To: ATA ad hoc Working Group

From: Pete McLean, Maxtor Corporation

Date: 27 November 1995/7 February 1996

Subj: Use of pins A-D On 44-pin connector

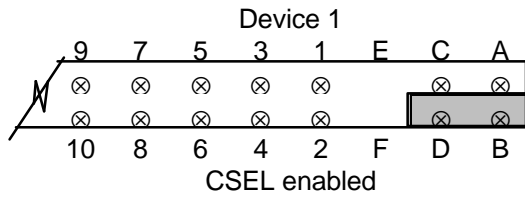
Today, the use of pins A, B, C, and D on the 44-pin connector is defined as vendor specific. Most, if not all, vendors are currently using these pins with jumpers to designate the device as Device 0, Device 1, or CSEL enabled. However, the specific position of the jumper varies from vendor to vendor. This results in confusion both for system vendors, configuring systems at manufacture, as well as, for users upgrading systems.

It would benefit the ATA device user community greatly if the use of these pins were specified so that all devices from all vendors were the same. Therefore, it is proposed that a statement be added to the description of these pins, recommending that if they are used for device selection jumpers, they be used in a specific way. In this way, over time all configurations will migrate to the recommended method and be the same.

The following configuration is proposed.

Note: Revision 1 of 7 February 1996 added figure comparing Maxtor, IBM and Toshiba proposals.

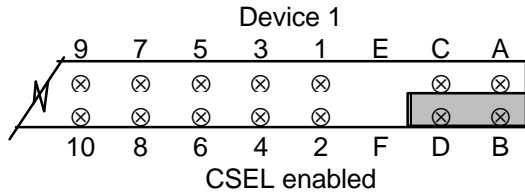
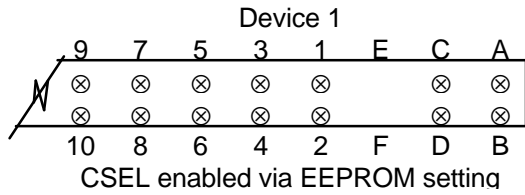
Note: Maxtor and IBM the same for CSEL.

Note: IBM and Toshiba the same for Device 0 .

Note: Toshiba and Maxtor the same for Device 1.
